## **MANISTEE CITY HISTORIC DISTRICT COMMISSION**

##### **HDC-2011-17 Vogue Theater, 383 River Street – Request for Certificate of Appropriateness Façade Modifications**

# HISTORIC DISTRICT COMMISSION

**05 November 2011 – Resubmittal for North Facade**

**PROPOSED DESIGN  
 NORTH ELEVATION**  
 SCALE: 1/4" = 1'-0"

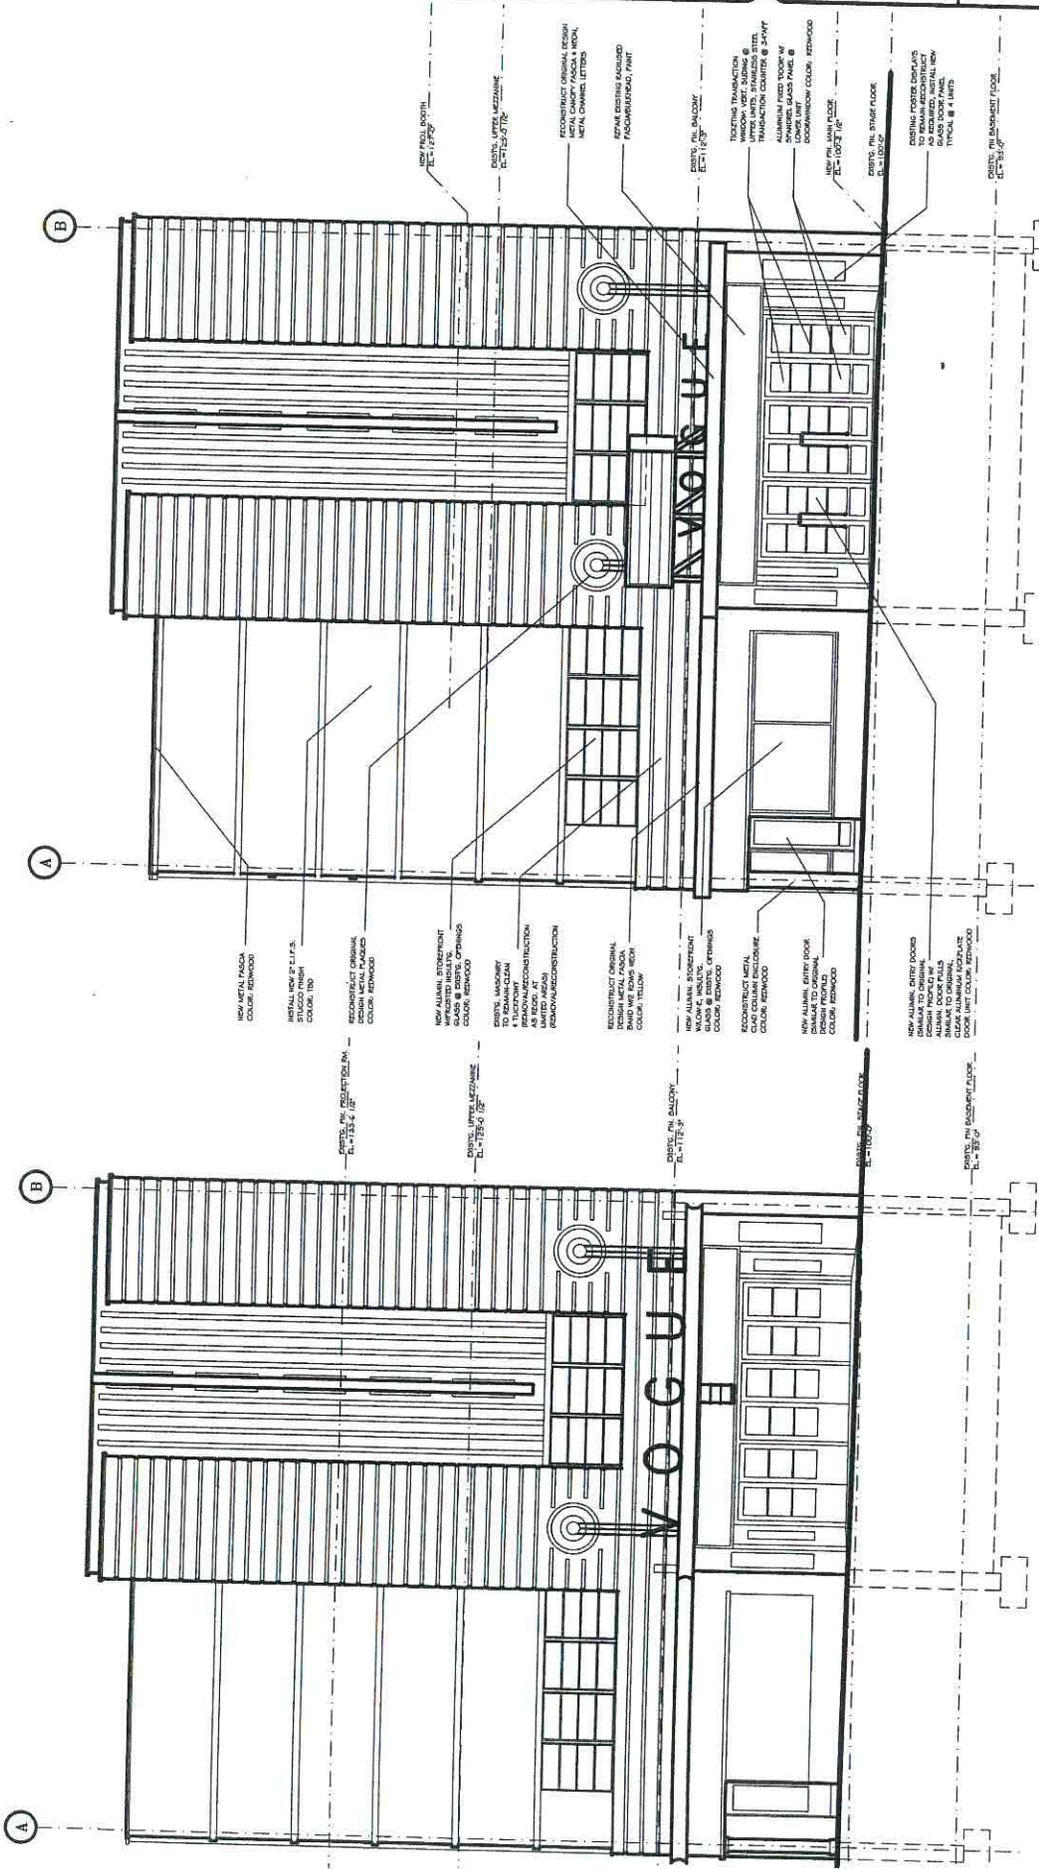
1. Redesign of the front entry including the loss of the recessed entry way and related historic features of that entry violates standard #2 and #5 This currently unaltered recessed entry is a major character defining feature, typical of Theatres of this period.

2. Modifications to the marquee/canopy. While it is unclear as to what remains of the original marquee canopy since it is covered with newer materials, it never had a broad horizontal signage board on top of it. Instead it had a rather thin and delicate profile highlighted at night with lights. The proposed horizontal signage dramatically alters this original feature and the character of the overhang. The addition of horizontal signage as proposed violates standard #3.

3. We are unclear as to whether or not the existing vertical sign is original or a later replacement. Original perspectives drawings for the building show a vertical sign with different lettering with the sign reaching dramatically above the roof line. However, early historic photos show a vertical sign that terminates closer to the roofline similar to the existing vertical sign. So it is unclear to us whether or not a taller sign ever actually existed. We recommend repairing and restoring the existing vertical sign unless adequate documentation that a taller sign actually existed. Without adequate documentation, the removal and replacement of the sign violates standard #3 and #5.

4. Replacing the existing stucco material with an EIF system. Though we have not reviewed details for this, there is a concern about dimensional differences resulting in loss of detail and reveals of the exterior front and east façades. It also involves remove or covering of existing historic details such as round medallions on the east side and may change the depth of reveals and shadow lines on other portions of the façade such as where the stucco abuts the brick.

Motion by John Perschbacher, seconded by Dave Carlson to deny the request for façade modifications to the North Façade of the Vogue Theatre, 383 River Street as submitted with application HDC-2011-13.

The Commissioners discussed the letter received from SHPO. If the change to the façade was allowed than any other property owner who wanted to could add a new entrance to the building; precedence would be established.

Upper window replacement with Kawneer 450 series aluminum storefront system, low-e insulating glass (frosted at upper units) with mullion configuration similar to existing. Color: Redwood.

Rehabilitation of existing corner pier with new aluminum clad flush panel. Color: Redwood.

Repair of existing radius fascia panel at recessed entry area. Paint. Color: tbd.

Rehabilitation of existing openings with Kawneer 450 series aluminum storefront system, low-e insulating glass, Ticketing Area at exist'g door area to be vertical sliders with mulls aligning with door mulls.  
Color: Redwood

Rehabilitation of existing openings with Kawneer 450 series aluminum storefront system doors with lites/mullion per drawings, door hardware similar to existing; Ticketing transaction area to simulate door profile with operable vertical sliding unit at upper area, 1-1'2" stainless steel transaction counter at 34" height above floor, lower lite with opaque spandrel glass.  
Color: Redwood
